High level constraint and capacity check

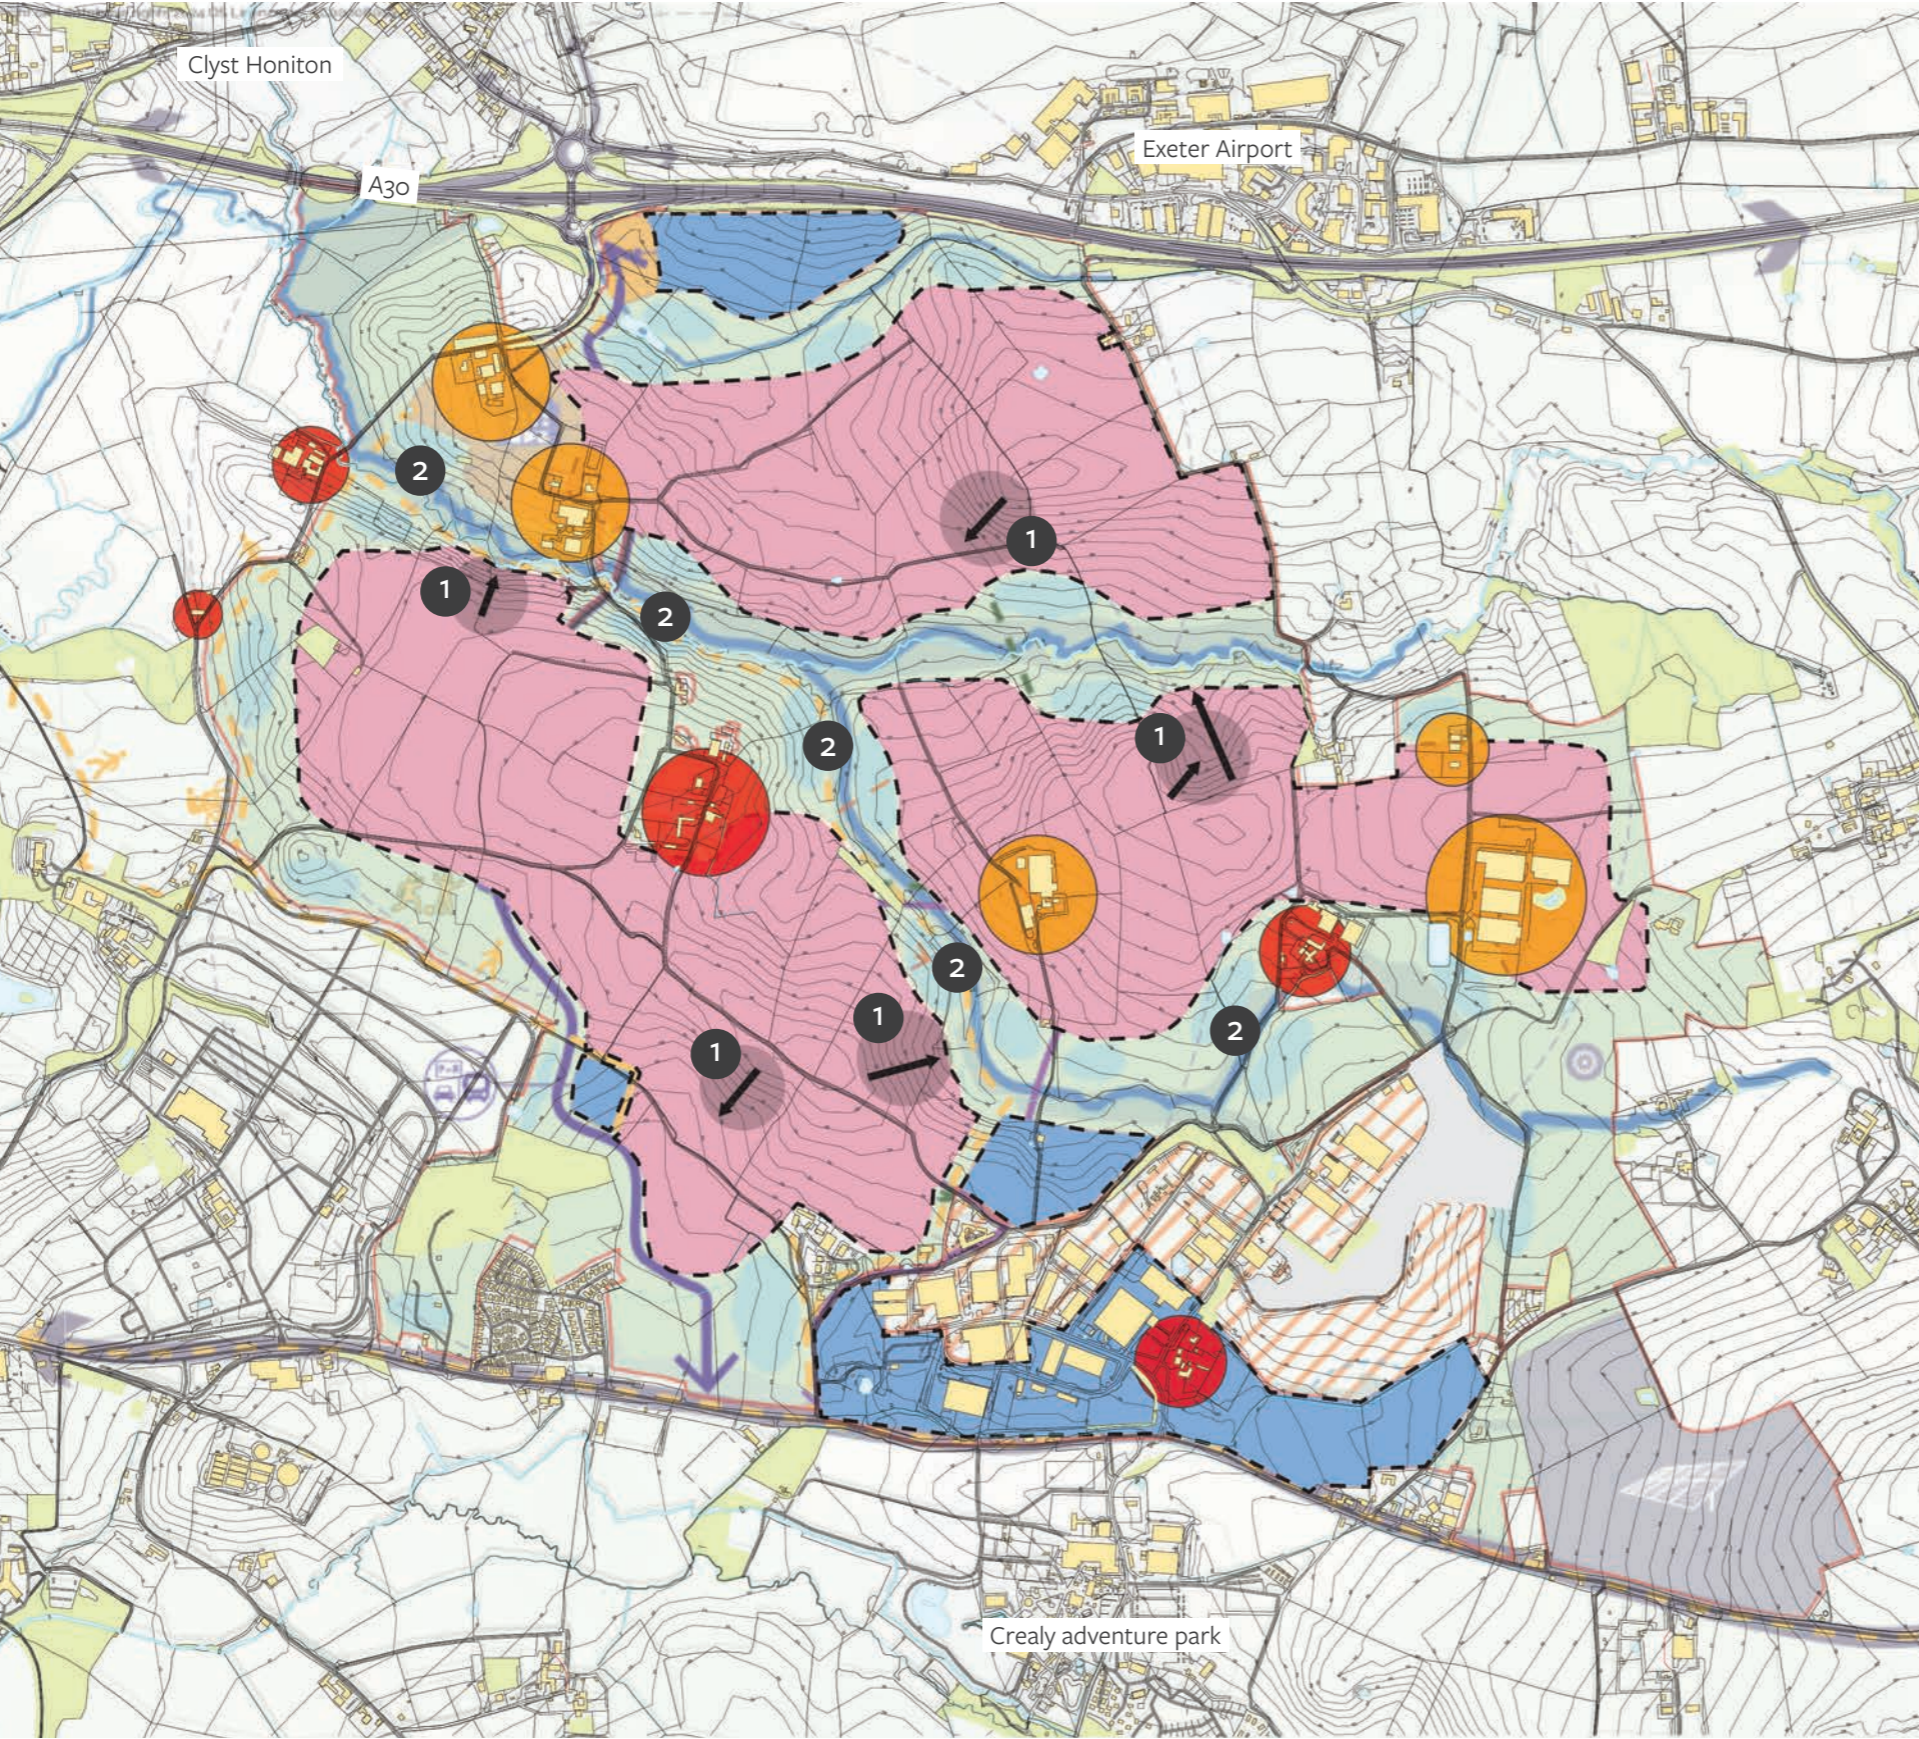
An average density of 44 dph seems high, and would typically take the form of terracing and apartment units - questions on whether this aligns with market demand.

Inconsistency in information - looks as though there is already existing development within the area suggested for proposed employment, and no development shown in areas of existing development.

Area of existing development and buildings contained within the residential zones - are these being kept or removed as part of the proposals?

Historically important/Listed buildings located within or within close proximity to proposal areas

1 Steep sloping areas within the current residential zones - gradients ranging from 1:6 - 1:9

2 Attenuation and drainage proposals suggested as part of the concept masterplan looks to be located in flood zones, and steep slopes - creating drainage solutions that would potentially be infeasible
